PARTS LIST FOR MODEL 30VW

MRP Ver 062022
 (based on Penn's Rev 0 First Run 2006)
30VW Before / Older

Penn Reel Parts list for Model: 30VW (Before Design Changes)

DESIGN CHANGES AND CORRECTIONS (REV 0)

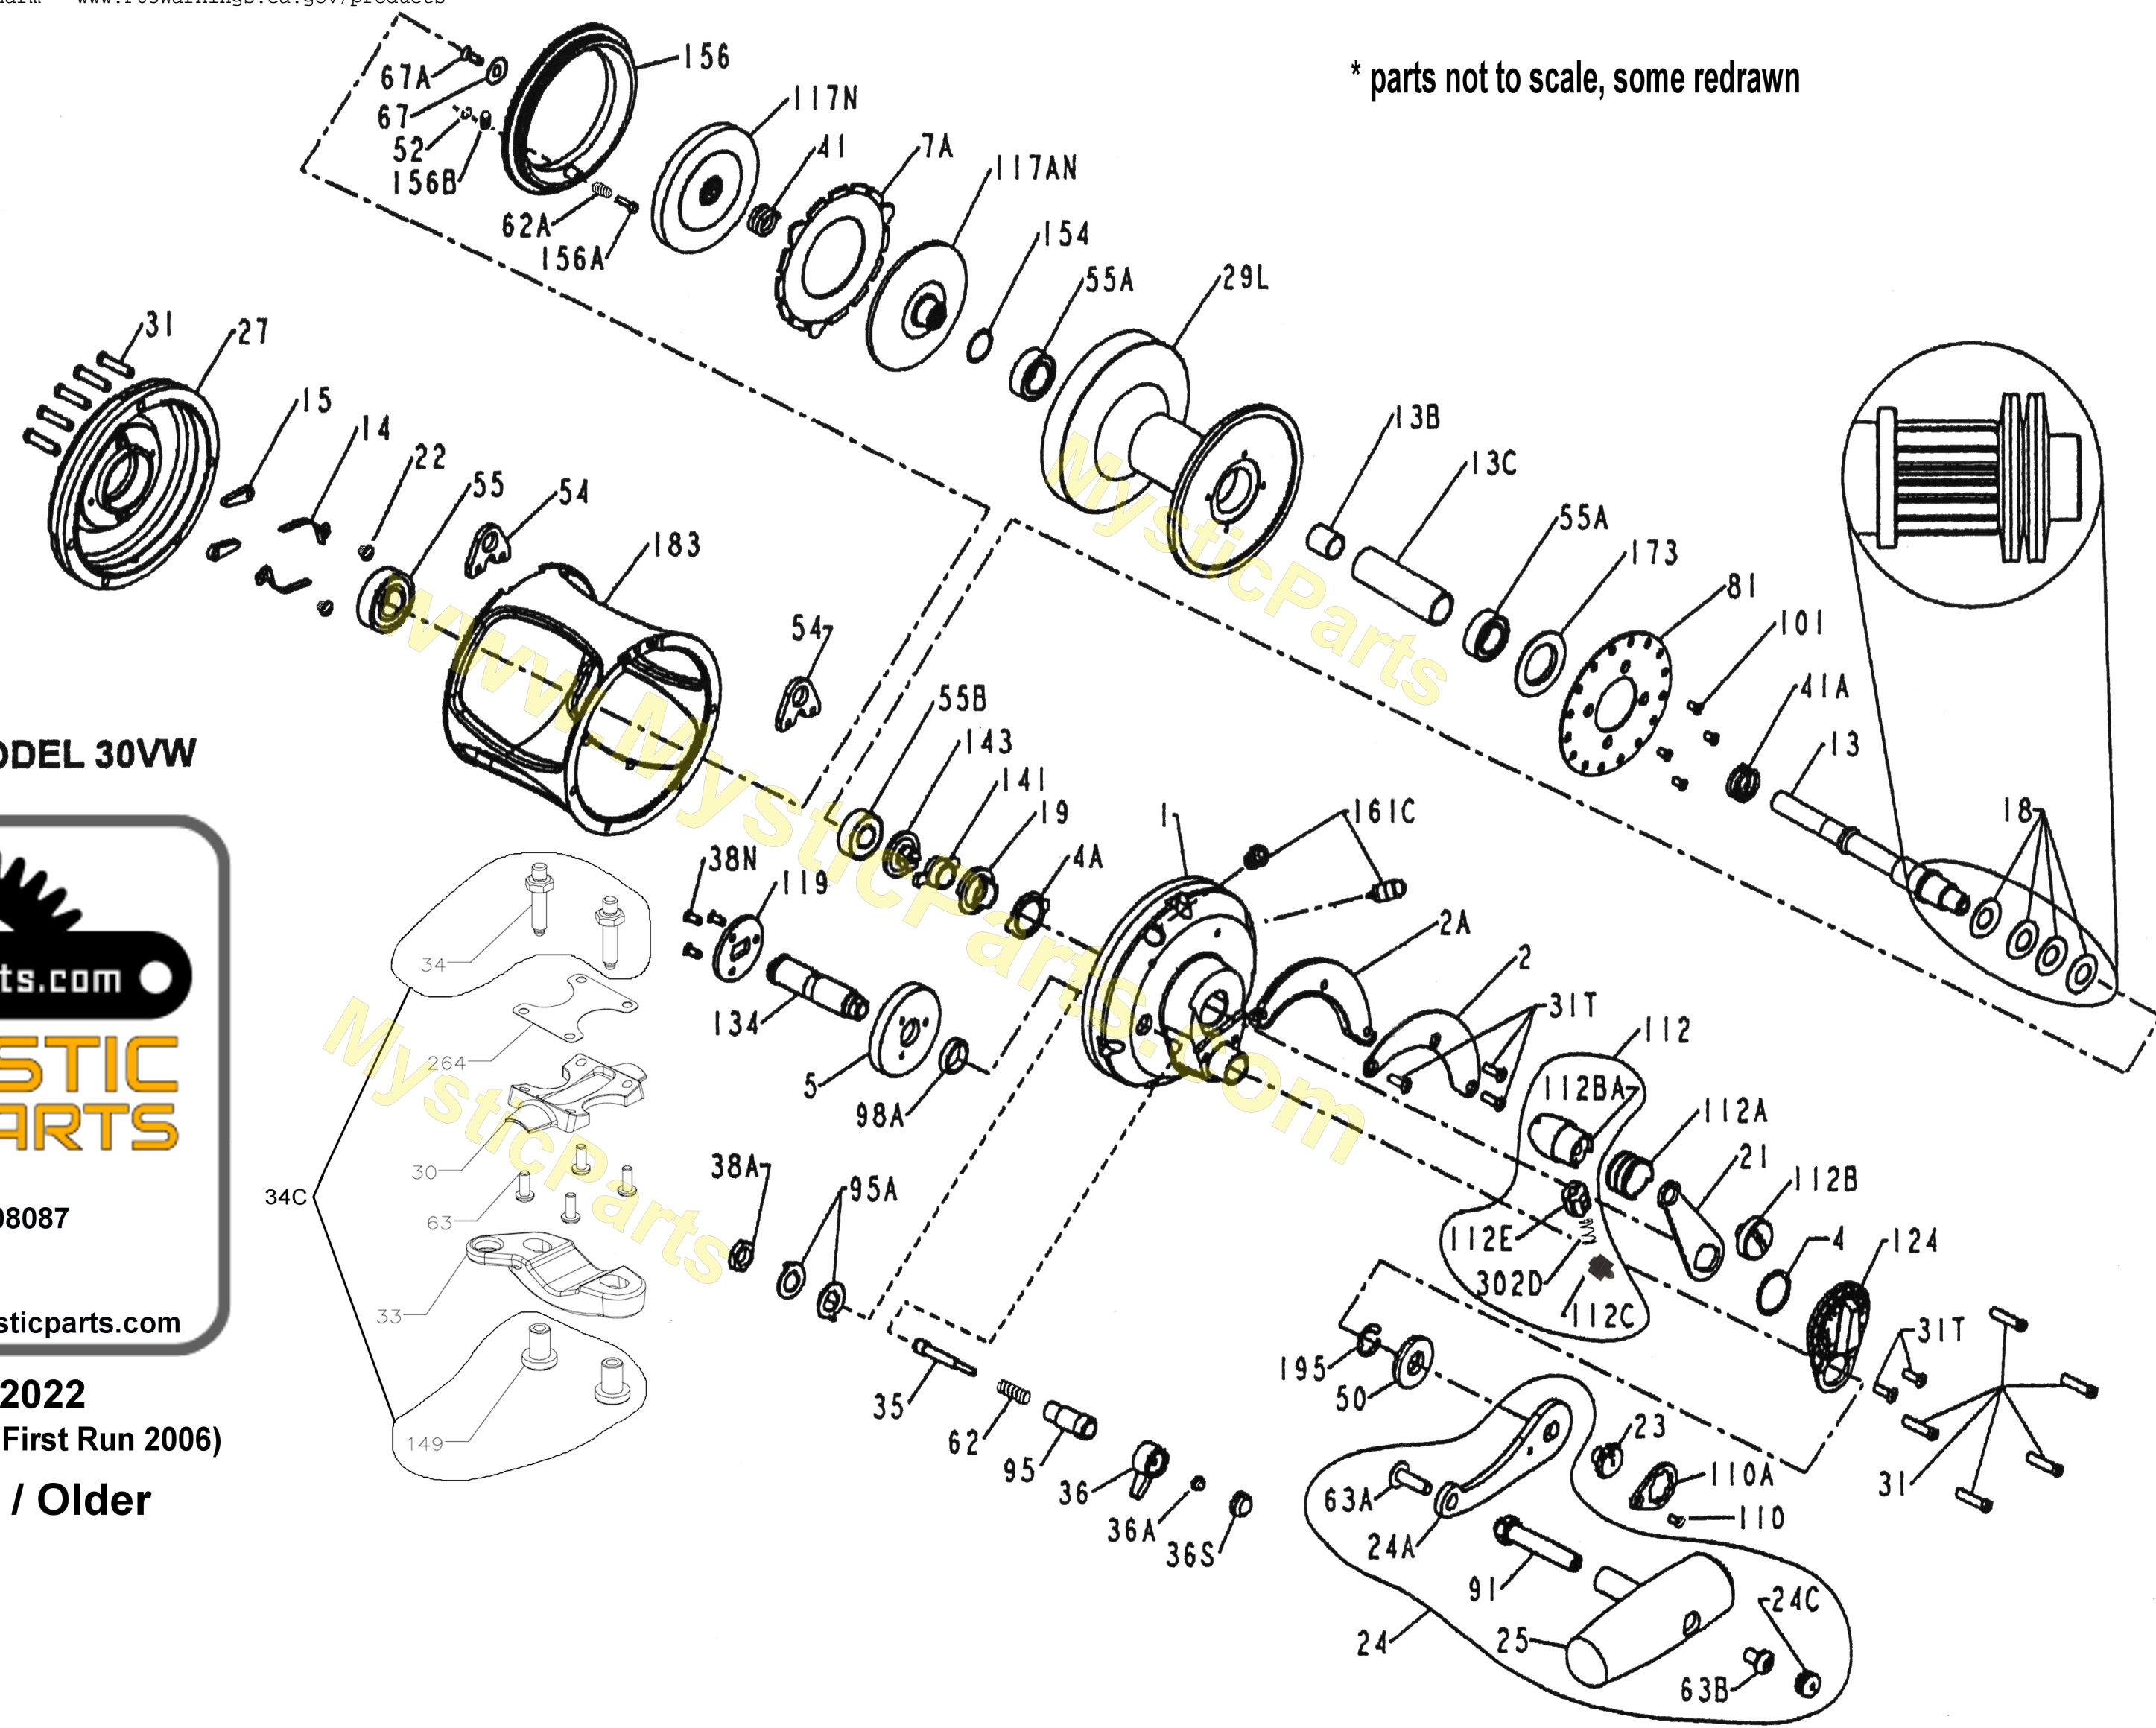
KEY	PENN PART	PUREFISHING	DESCRIPTION
NO	PART #	PART #	
	DO NOT USE THIS 7 digit NUMBER		
30	30-30VS OLDER	4491554	STAND, HALF MOON CUTOUTS (older version is NOT available)
264	264-30VS OLDER	4492542	STAND GASKET, HALF MOON CUTOUTS (older version is NOT available)
183	183-30VW OLDER	4492738	TUBE FRAME Original with screw holes for older studs 34-70 (not available)

THESE 3 PART NUMBERS WERE REDESIGNED in their Rev 00 thru 6 schematics
PENN DID NOT ASSIGN THE NEW PARTS NEW 7 DIGIT #S !! So be careful

IF THE PARTS IN THE DRAWING DO NOT MATCH YOUR REEL, SEE THE 30VW_after SCHEMATIC OF the NEWER VERSION
THIS IS IMPORTANT AS THE STUD SCREWS ARE ALSO OF A DIFFERENT DESIGN

Older style studs that screw UP into the frame

33C	33C-70	1182771	Rod Clamp Kit Clamp/Studs/Nuts/Wrench (Older Version)
34	34-70	1182793	CLAMP SCREW, SCREW UP STYLE (2 REQUIRED)
34C	34C-70	1182865	ROD CLAMP SCREW W/NUT, SCREW UP STYLE NUT

After the 1st run they changed over the design to drop in studs, so major parts changes from rev 00 thru rev 6
